Docket Item # 4  
BAR CASE # 2009-0092

BAR Meeting  
May 27, 2009

**ISSUE:** Addition/Alterations

**LOCATION:** 1105 Queen Street

Figure 4. Existing and proposed front elevation.

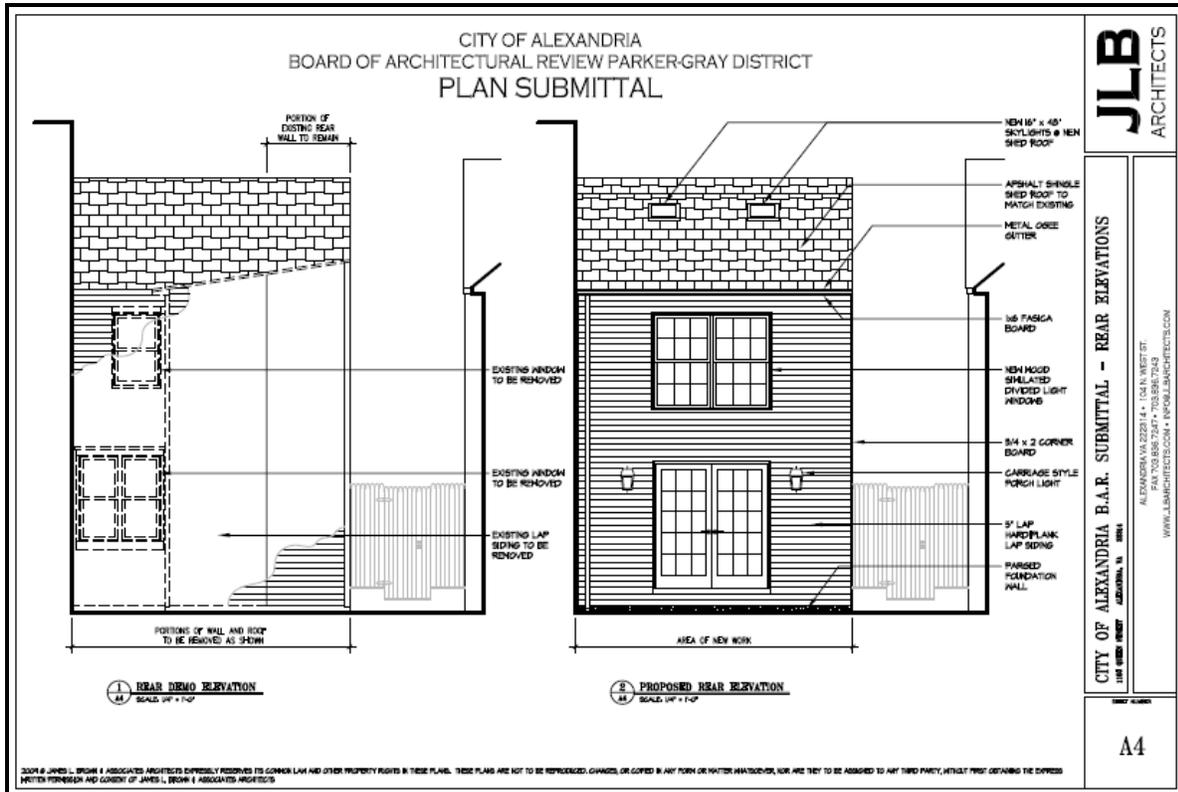
On the front façade, the applicant is proposing fenestration replacement and reconfiguration. The proposed alterations include the replacement of both second story windows with Kolbe and Kolbe, six over six, wood, simulated divided light, double-glazed windows. The applicant is proposing the removal of the paired, double window on the first story and replacement with a single six over six Kolbe and Kolbe window to match those used on the second floor. The applicant is proposing the replacement of the existing shutters with new 16 inch wide wood shutters.

While according to the Design Guidelines, "single glazed true divided light wood windows," are preferred, it also states that in situations where the windows are located on an elevation that is minimally visible a simulated divided light window would be acceptable. In the same vein, Staff does not object to an insulated glass paneled door. Again noting the distance of the setback of the new addition, in Staff's opinion, the proposed skylights will be minimally visible and therefore staff does not object to their installation. While Staff does not object to the use of double-glazed, simulated divided lights on the rear elevation, to maintain the historic integrity of both the front façade and the streetscape, Staff finds that a wood, single-glazed, true divided light window with the option of exterior storm windows would be a more appropriate replacement. Staff does not object to the replacement of the existing shutters with new wood shutters. Staff

In Staff's opinion, due to the age of the building, the applicant's proposed redesign of the fenestration and wood trim on the front façade returns the home to the Greek Revival vernacular style of the time period of its original construction. Because the proposed addition is a modest expansion of an existing historic feature, is minimally visible, and will not affect the integrity of the historic portions of the structure, Staff recommends approval of the application.

2. That the applicant use wood, six-over-six, single glazed, true divided light windows on the front façade with the option of storm window installation.

3. That the new wood shutters be operable.
4. The applicant/developer shall call Alexandria Archaeology immediately (703-838-4399) if any buried structural remains (wall foundations, wells, privies, cisterns, etc.) or concentrations of artifacts are discovered during development. Work must cease in the area of the discovery until a City archaeologist comes to the site and records the finds.

Figure 5. Existing and proposed rear elevation.

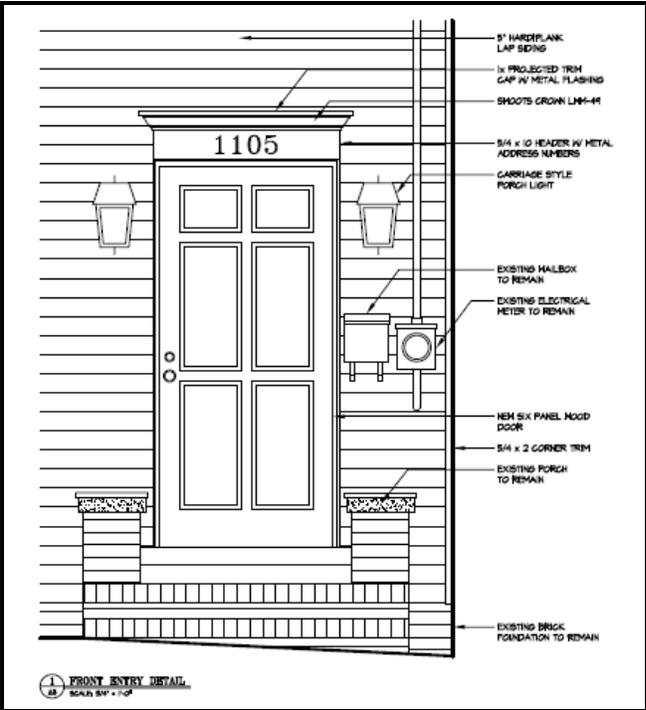
Along the rear roofline of the addition a new metal gutter and downspout will be installed. On the second floor of the new north wall the applicant has proposed one double Kolbe and Kolbe, Heritage series, double insulated, simulated divided light, wood window in a six-over-six configuration. Directly below the double window on the first floor, the applicant has proposed a Kolbe and Kolbe Heritage Series, wood, inswing French door with a fifteen light, simulated divided light pattern. Mounted on either side of the new French doors the applicant is proposing the installation of new Kichler, carriage style porch lights in a bronze finish.

Due to the fact that the proposed addition is located at the rear of the historic structure, is not readily visible from Queen Street, and is deeply set back, approximately 55 feet, from a public alley at the rear of the property, Staff does not object to the use of Hardieplank siding as a construction material on the new construction, however, when using Hardieplank in the historic district, the panels must be smooth and installed so that the nails cannot be seen. While Staff finds Hardieplank to be a compatible material for the new construction, Staff is unable to support its use on the front façade. In Staff's opinion, due to the age of the home and the existing aluminum siding, Staff recommends that the applicant pursue discovery of historic wood siding, at which point, if none exists, or Staff determines that it irreparable, solid wood siding would be the appropriate replacement material.

1. That the applicant work with Staff to determine the existence and/or condition of historic wood siding beneath the existing aluminum siding on all retained elevations of the historic house, and if historic siding is found that the applicant work with Staff to determine if the historic siding can be retained and repaired, or if the siding cannot be retained, new wood siding be used for replacement, and that the applicant work with Staff on the final configuration.

Figure 6. Front entry detail.

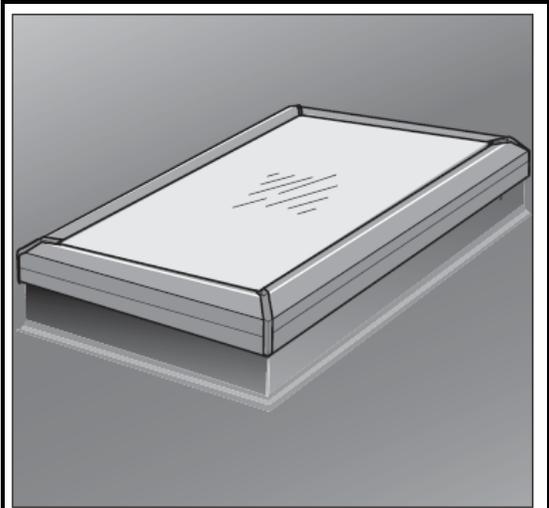
The applicant is proposing the replacement of the existing front door and surrounding trim with a new wood cornice and six paneled wood door. The applicant has also proposed the replacement of the existing lighting with new Kichler, carriage style porch lights in a bronze finish, the same as those proposed for the rear elevation. The applicant has indicated that the same Hardiplank, 5 inch lap siding proposed for the new rear elevation is also proposed to be used to re-side the front façade. The applicant is proposing the installation of new wood, 5/4 x 2 inch corner board on the eastern edge of the house that abuts 1103 Queen Street.
